INDEPENDENT ORBITER ASSESSMENT

ASSESSMENT OF THE FMEA/CIL INSTRUCTIONS AND GROUND RULES

14 OCTOBER 1986

WORKING PAPER NO. 1.0-WP-VA86001-01

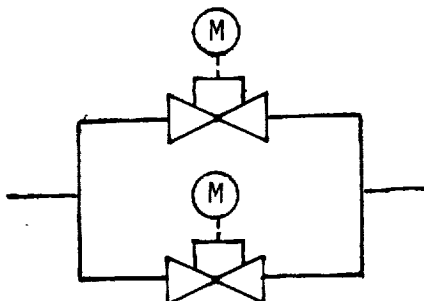
Problem: No provisions exist in Rockwell 100-2G to assure that FMEA/CIL identified failure modes are detected during ground turnaround. The Preliminary Draft of NSTS 22206 contained a provision to maintain a OMRSD matrix to track FMEA/CIL items against the OMRSD. Although the matrix was not adopted as part of the approved NSTS 22206, Basic, it will be maintained as an independent entity and will make reference to the FMEA/CIL identified items. In-flight verification of redundancy and the assurance that failure modes do not exist is at least as important as ground turnaround.

Recommendation: It is recommended that a matrix similar to the OMRSD matrix be adopted to provide tracability between in-flight checkout and critical items, to provide an awareness by both the crew and the ground in advance of potential problems.

Figure 3 - NSTS 22206 (Figure 1) FMEA/CIL Screening Process

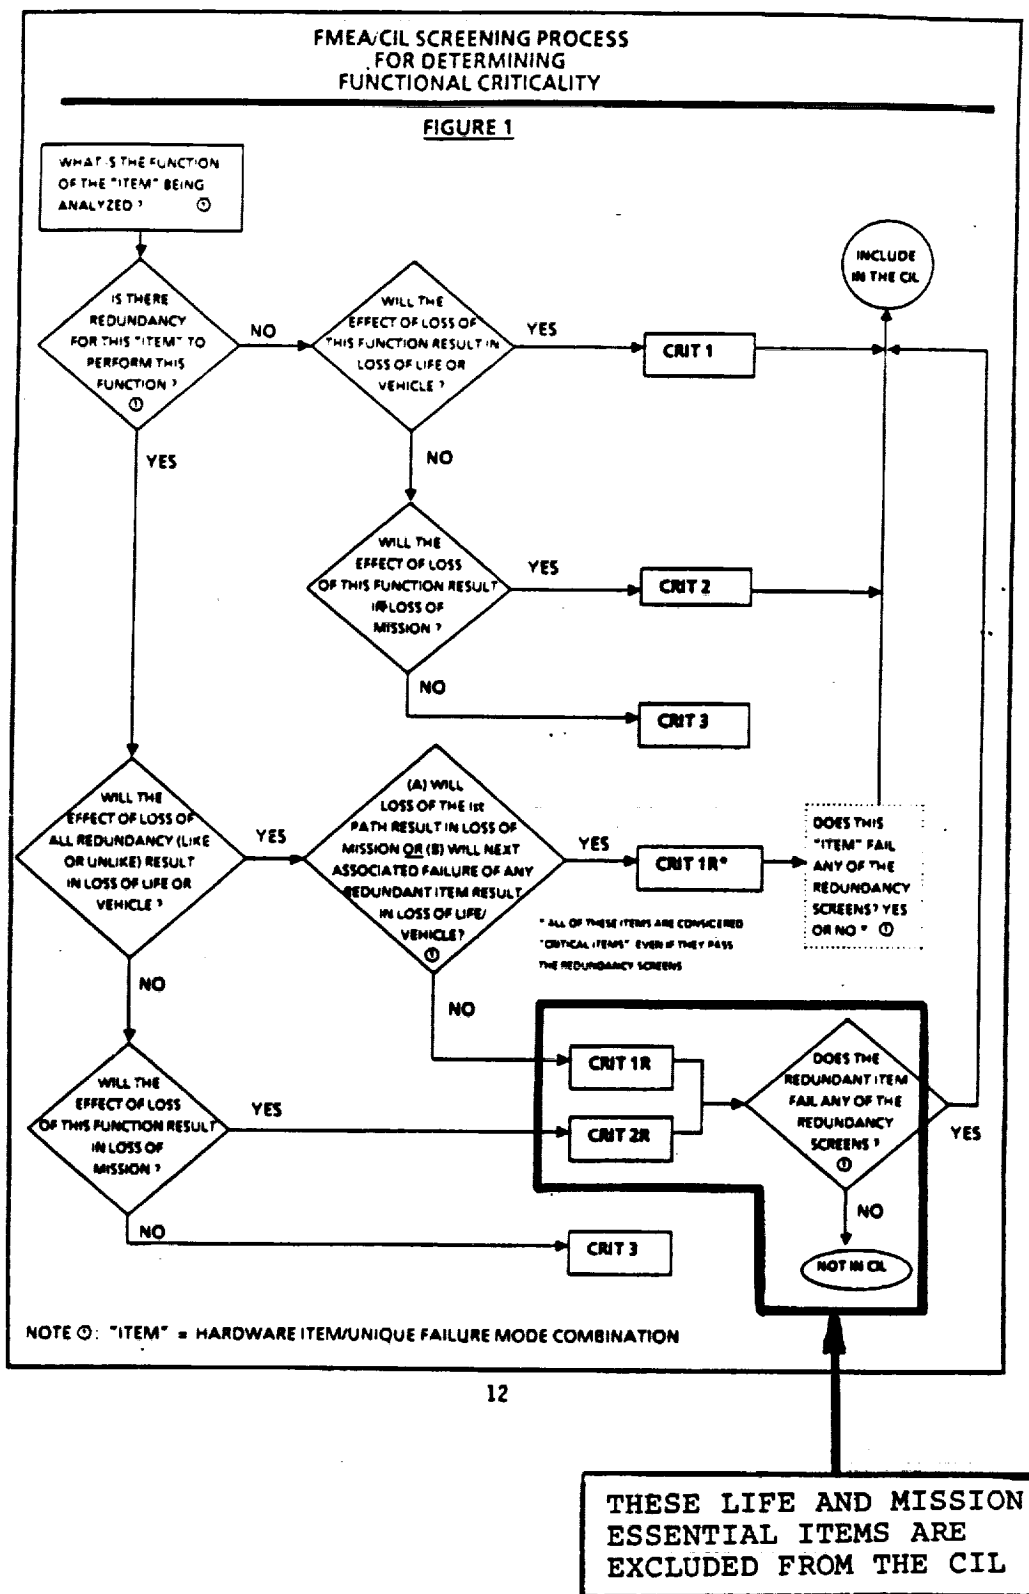
Problem: This figure is a logic road map for defining which orbiter items appear on the CIL. Two criticality categories are used: functional (which does not consider redundancy) and hardware (considers redundancy). Items that perform critical functions, but meet defined redundancy levels, and pass screens and are excluded from the Critical Items List (CIL). This exclusion creates a void in the control/assessment process. Attention and controls during manufacturing, assembly, test, failure reporting, corrective action review, and flight readiness reviews are less effective when all hardware that performs critical functions is not considered or treated. As a result, potential problems (latent manufacturing/design defects) with hardware may slip through the assessment process without management knowing the seriousness of the effects of failure.

Recommendation: Based on the Presidential Commission Report's position on management awareness, it is our recommendation that all automatic ground rules for excluding functional criticality 1R or 2R items from the CIL be eliminated and that, if items are to be eliminated, they be brought forward to the NSTS Program Level II change board for approval. In support of this position, it is recommended that the figure be replaced with a new figure shown as "Streamlined" replacement. Hardware criticality, in NSTS 22206 Figure 1, is replaced with a notation showing how many paths are available to accomplish the critical function.

FIGURE 1

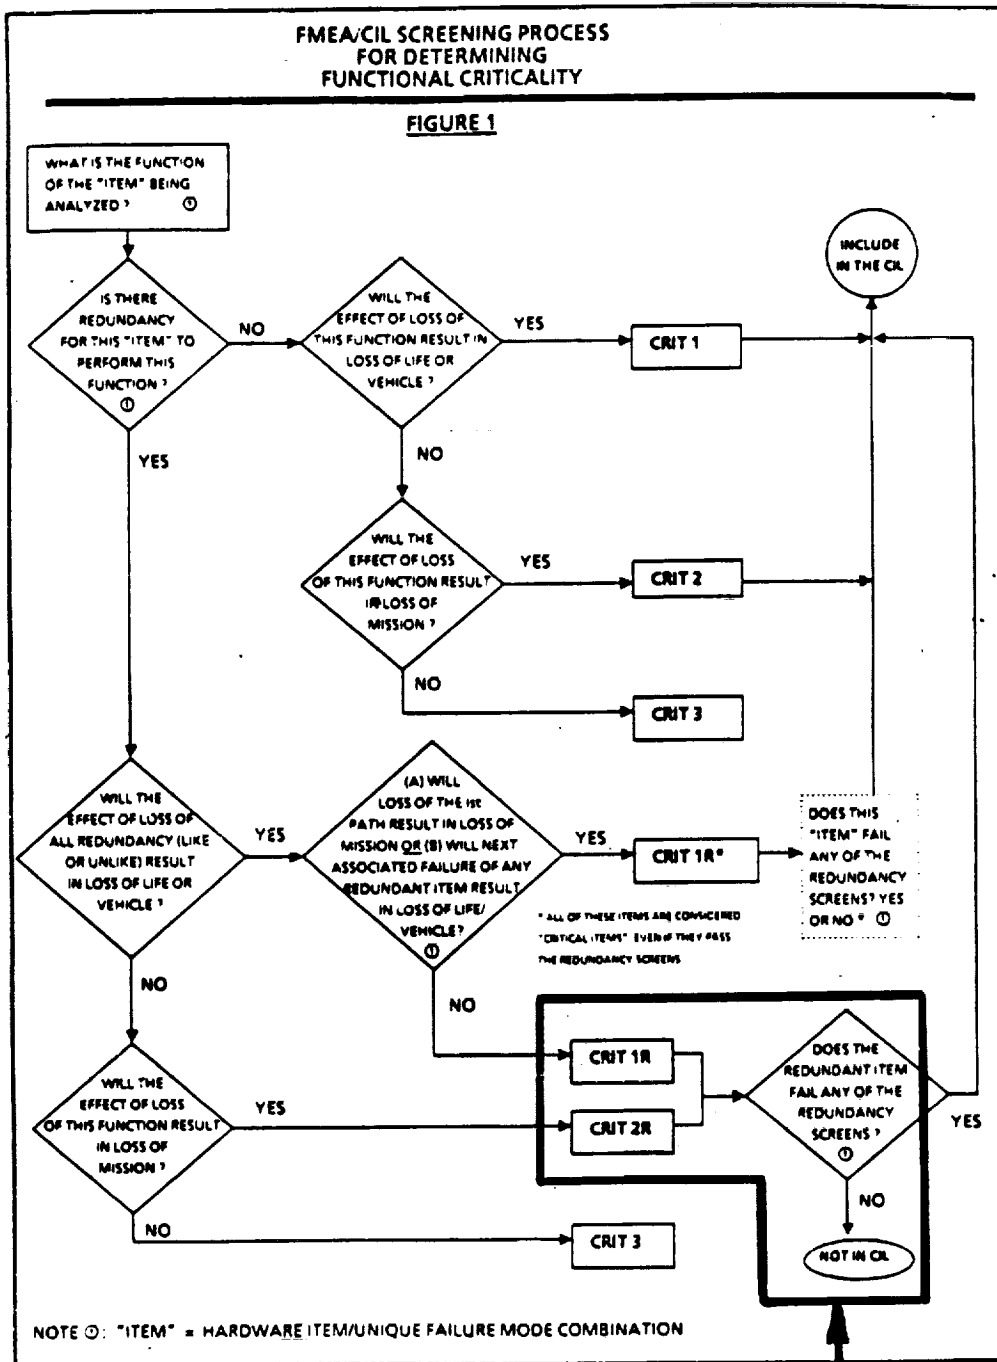
THESE LIFE AND MISSION
ESSENTIAL ITEMS ARE
EXCLUDED FROM THE CIL
